COUNTRY CLUB HEIGHTS EROSION CONTROL PROJECT

Feasibility Report

With December 2016 Erratum

Errata Sheet for the Country Club Heights Erosion Control Project Feasibility Report CIP 95191.

LAND USE AND LAND CAPABILITY MAP

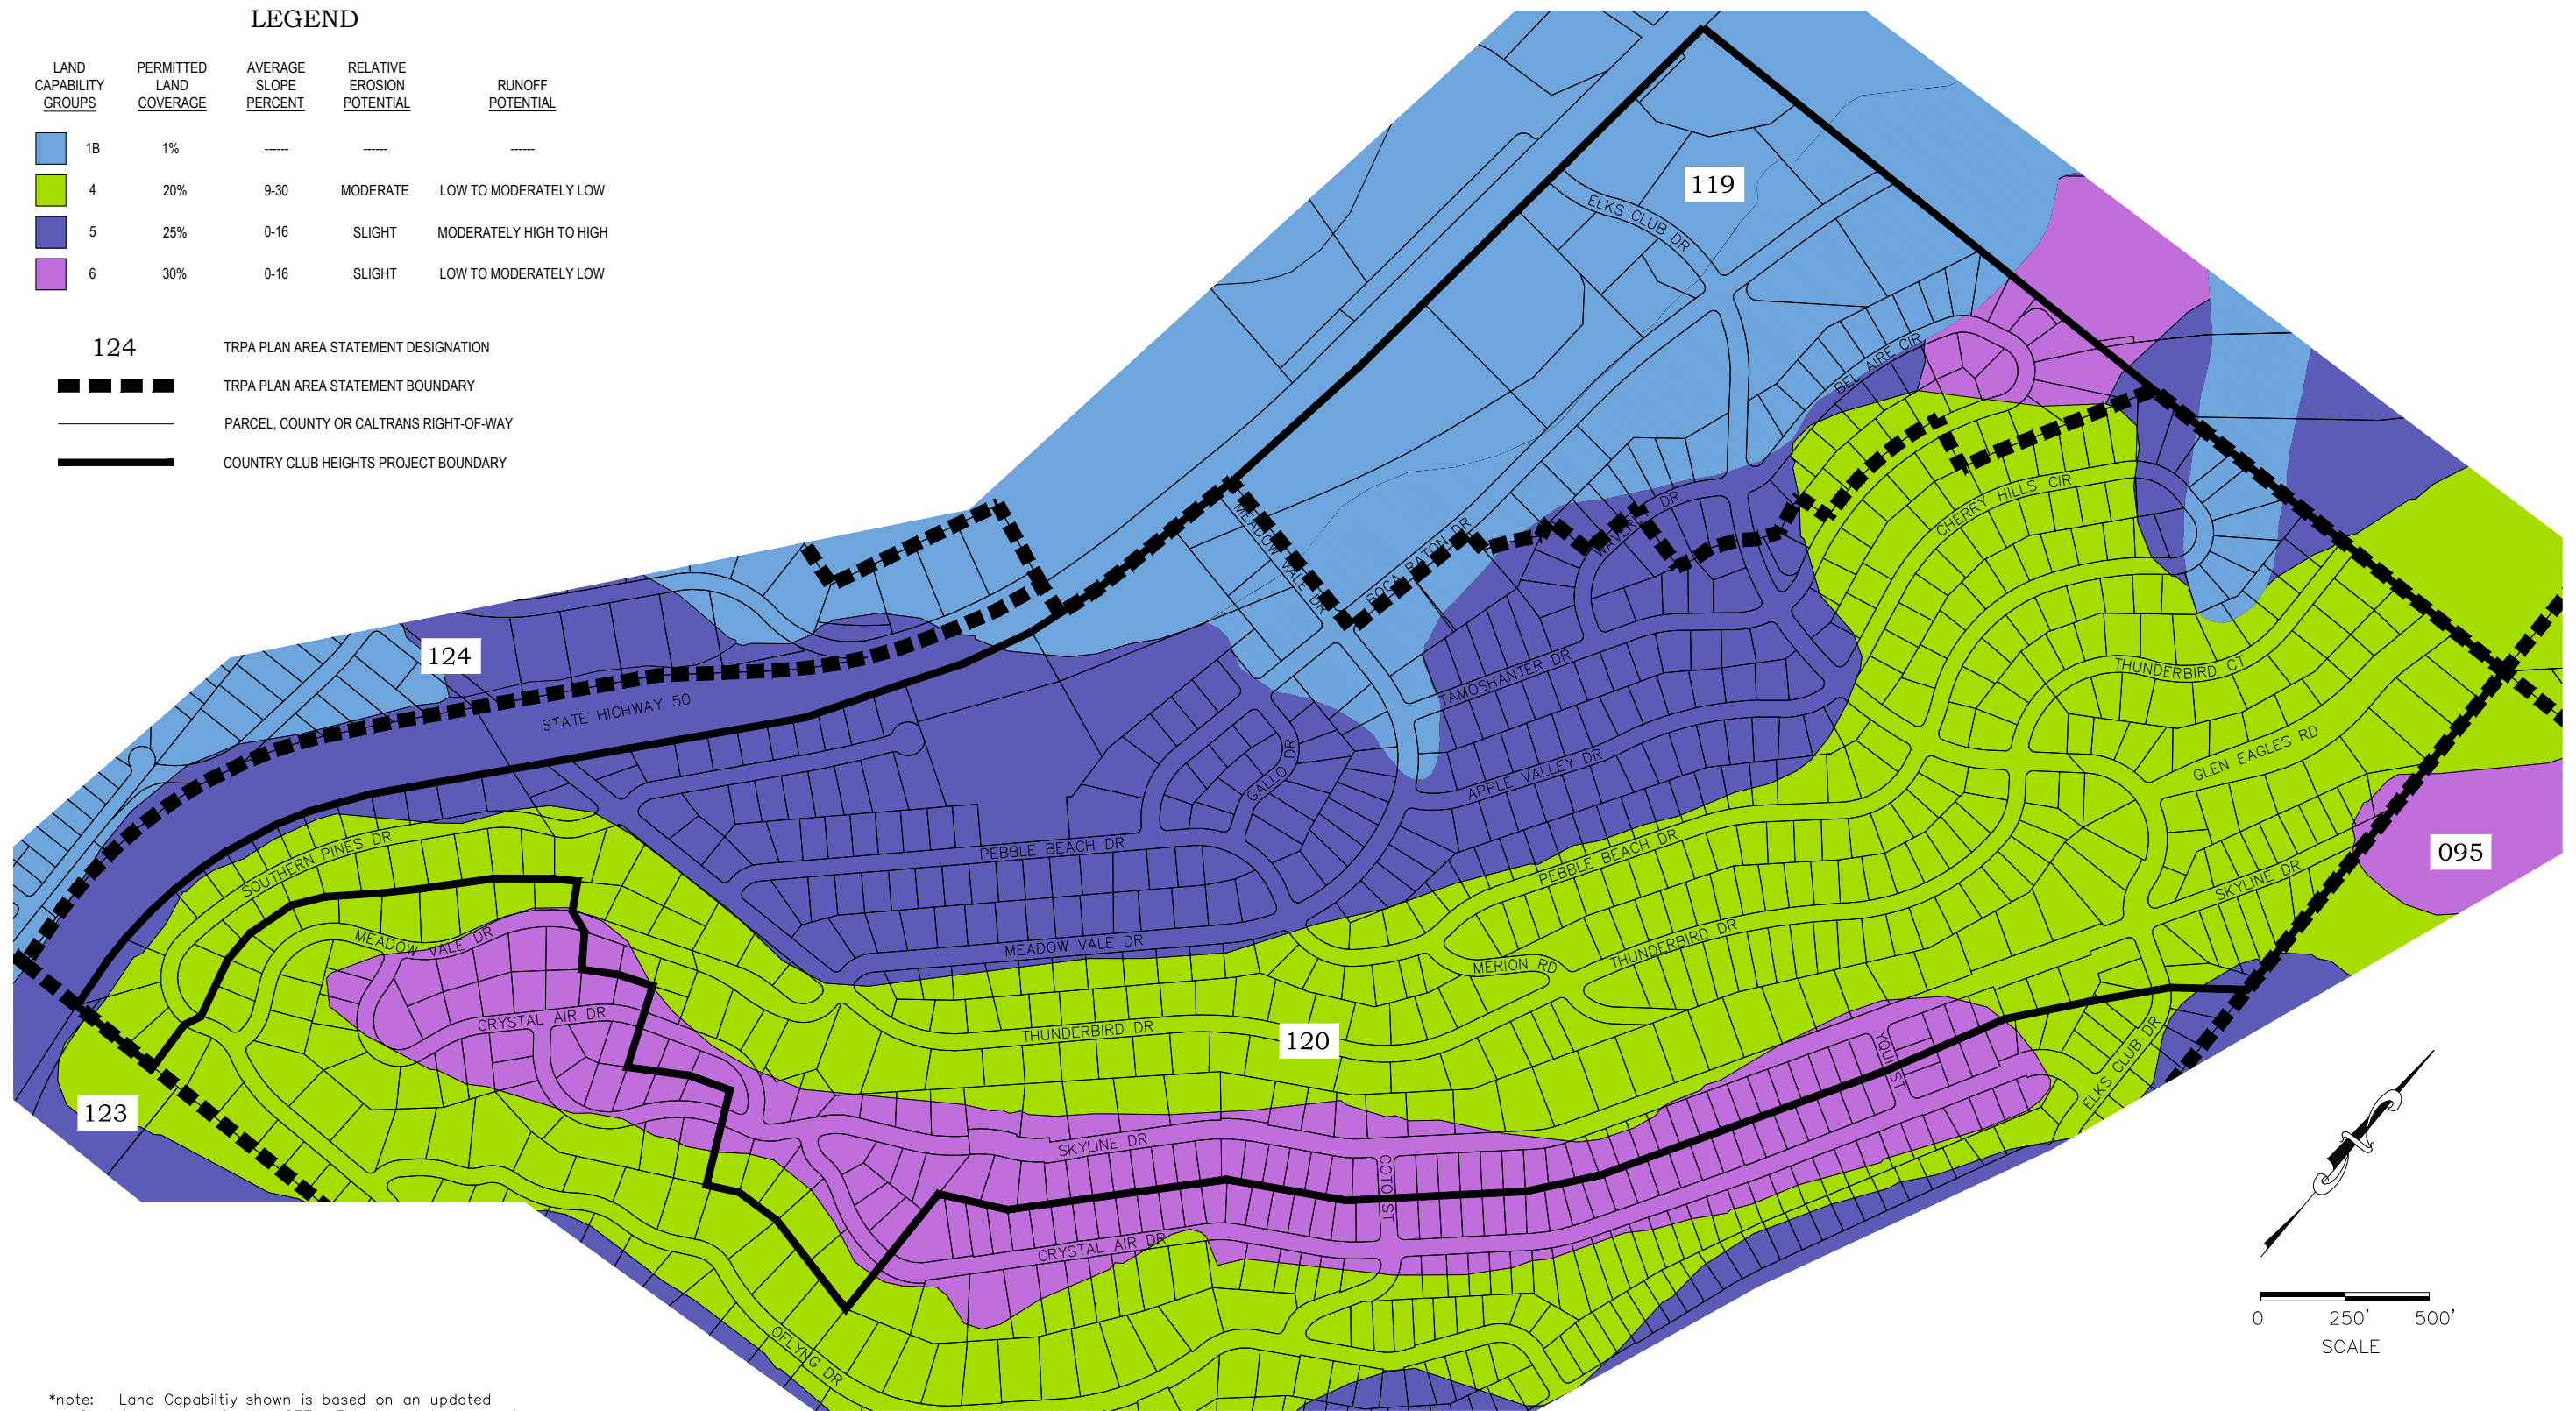
- Section 3.5 (page 14) – updated text to reflect use of Bailey Land Capability data as opposed to Sinclair Land Capability data. Figure 7 (page 15) was updated to reflect this change as well.

COUNTY OF EL DORADO COMMUNITY DEVELOPMENT AGENCY TRANSPORTATION DIVISION		COUNTRY CLUB HEIGHTS EROSION CONTROL PROJECT		FIGURE 17
	PROBLEM AREA MAP		DATE: 10/2016	PROJECT NO.: 95191

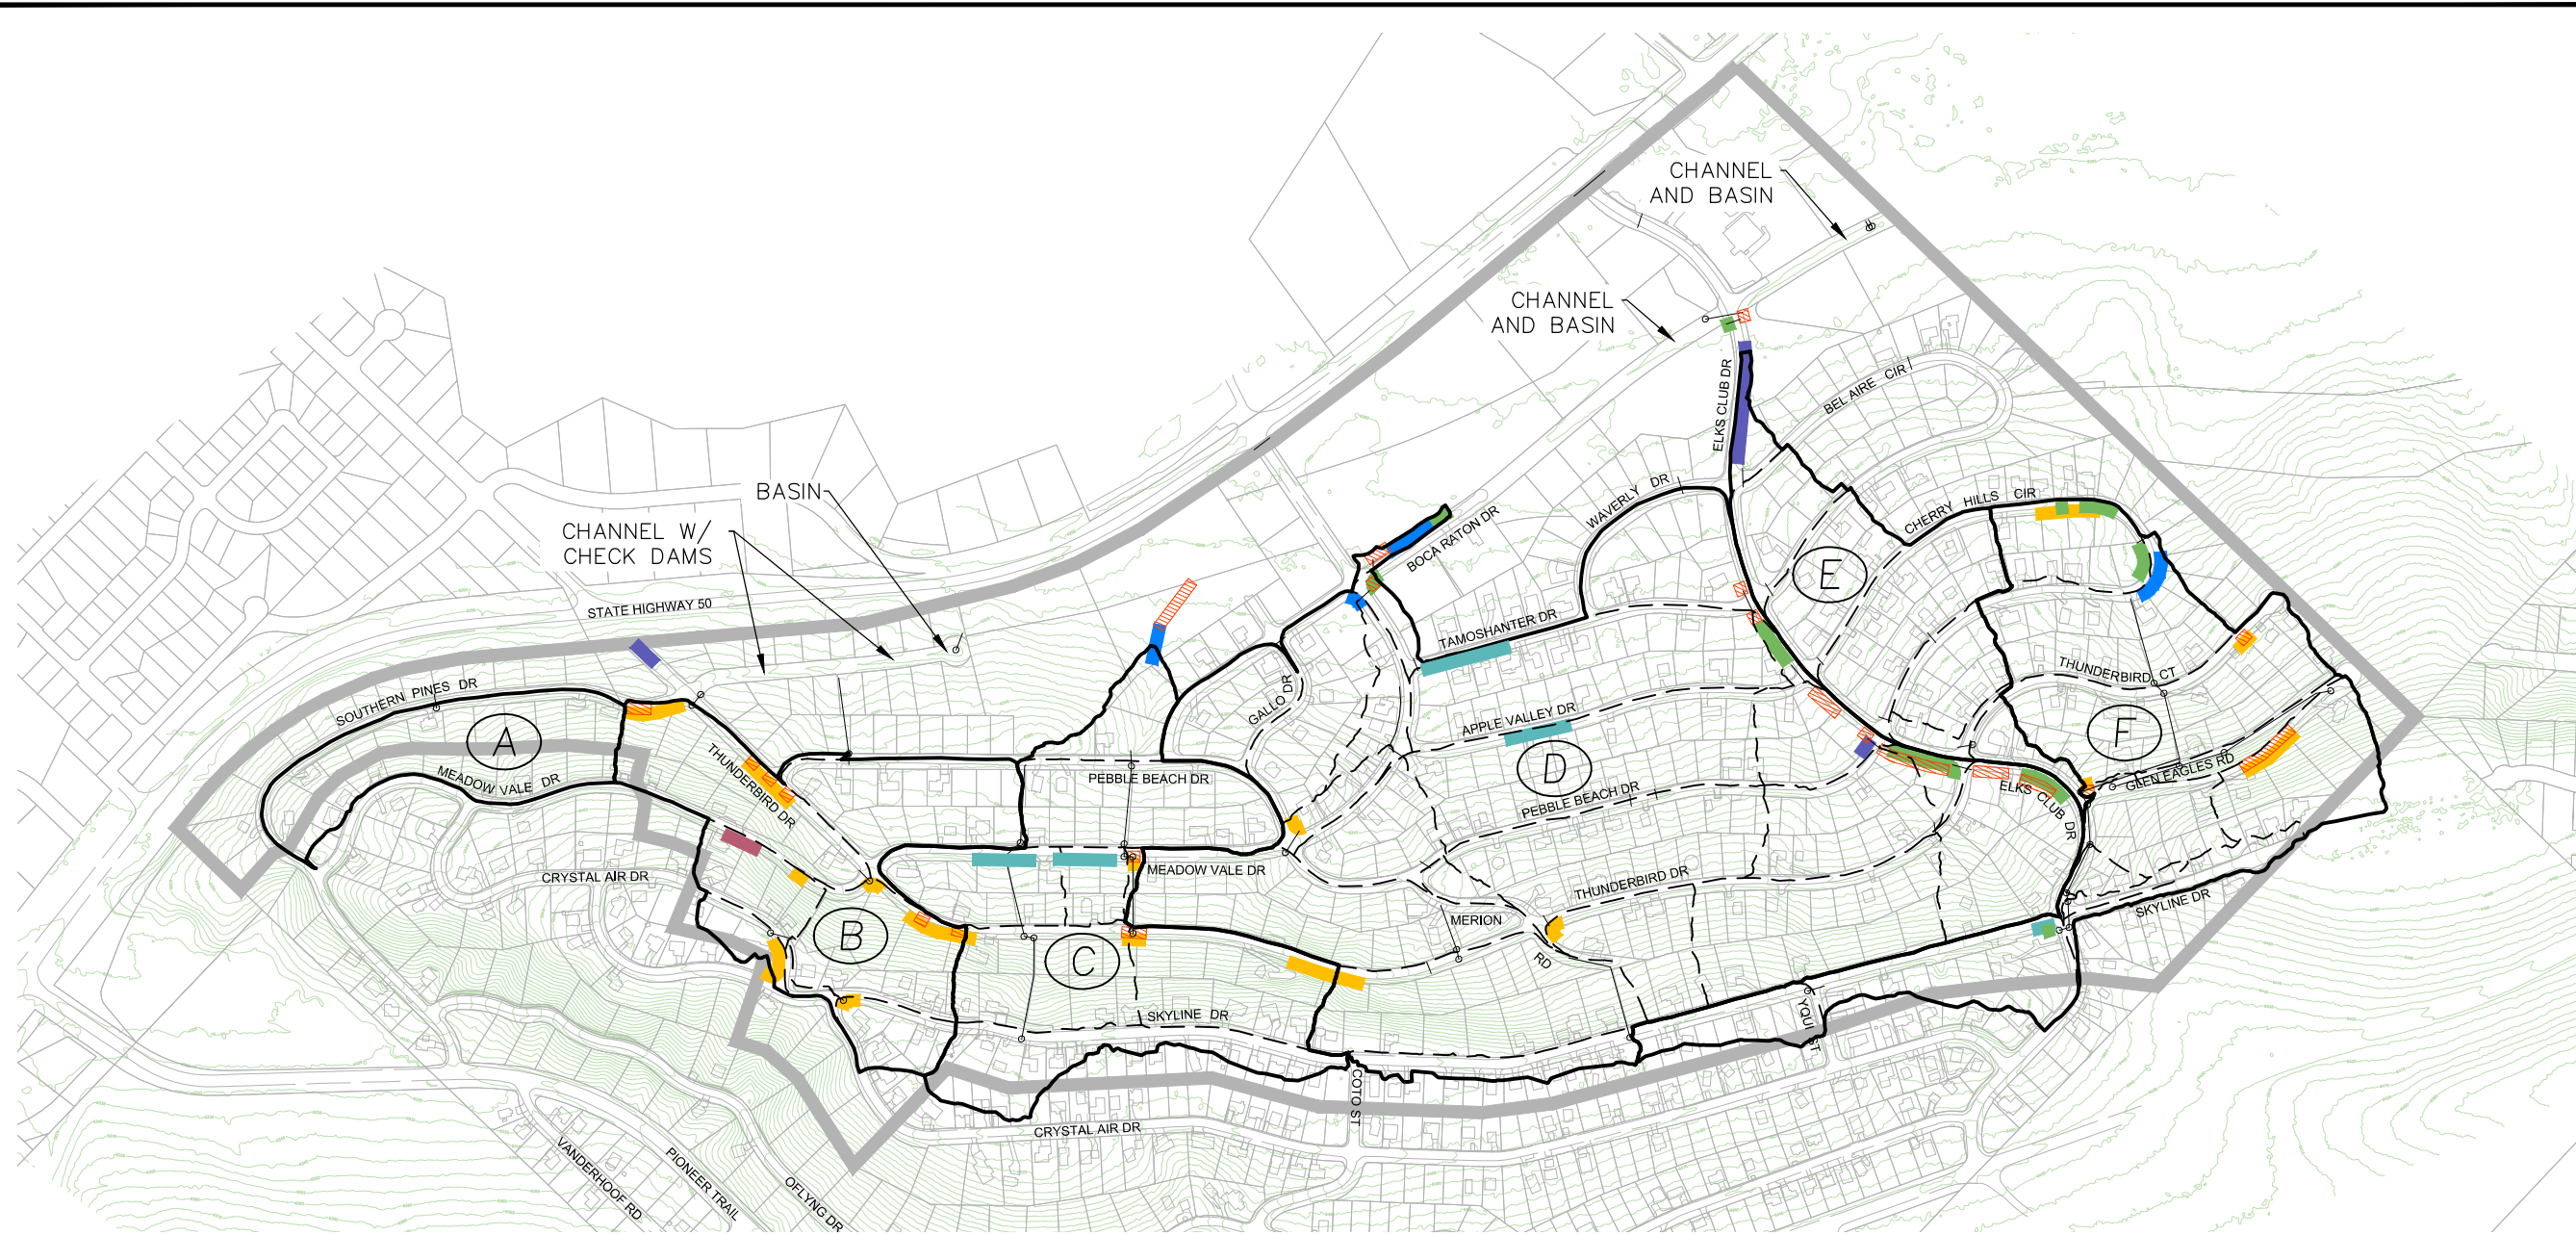
- Figure 17 (page 28) – updated to include additional problem areas identified by the public and County maintenance. Includes:
 - Ponding issues on Tamoshanter Drive (near Meadowvale Drive), Meadowvale Drive (between Pebble Beach Drive and Thunderbird Drive), and Skyline Drive (at Elks Club Drive).

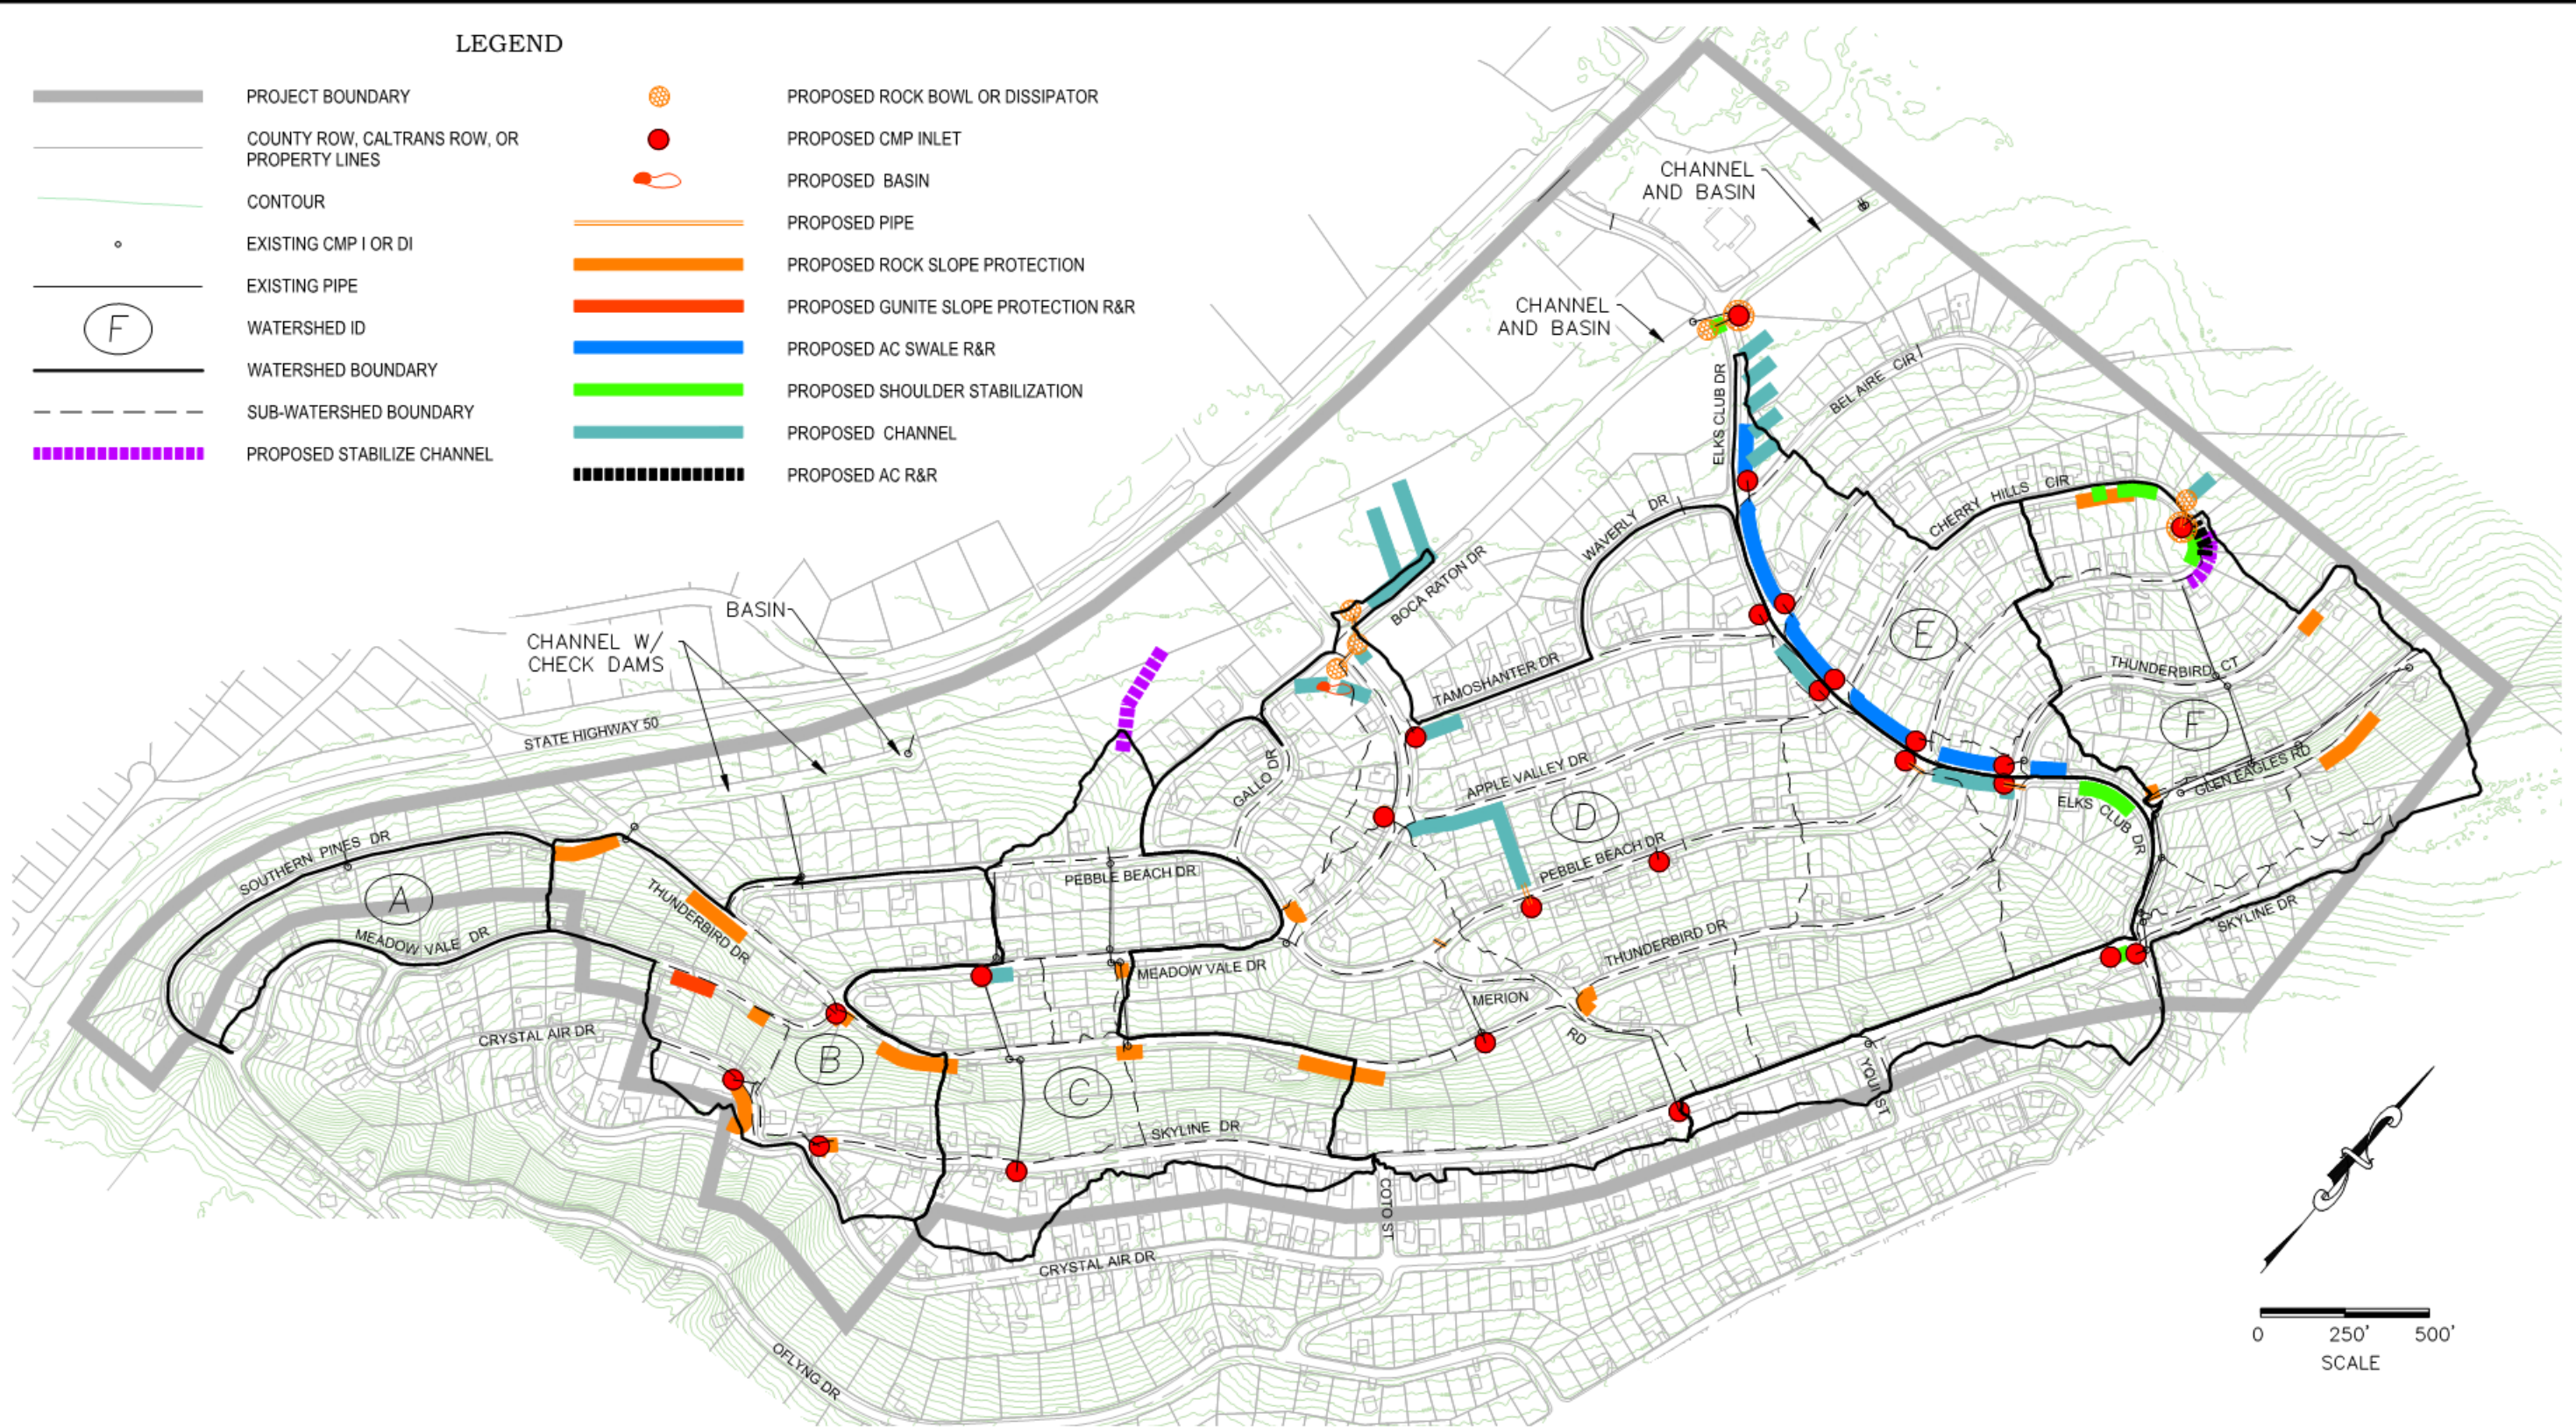
- Figure 18 (page 45) – updated to reflect following changes:
 - Shorted new channels into the meadow system off of Boca Raton Drive to reflect that constructed improvements will be on parcel 033-22-305 and not on parcel 033-22-304.

- Added channel to Tamoshanter Drive (at Meadowvale Drive)
 - Relocated proposed CSP Inlets from 1) Yqui Street to Skyline Drive at Elks Club Drive and 2) one on Thunderbird Drive to Meadowvale Drive (between Pebble Beach Drive and Thunderbird Drive).
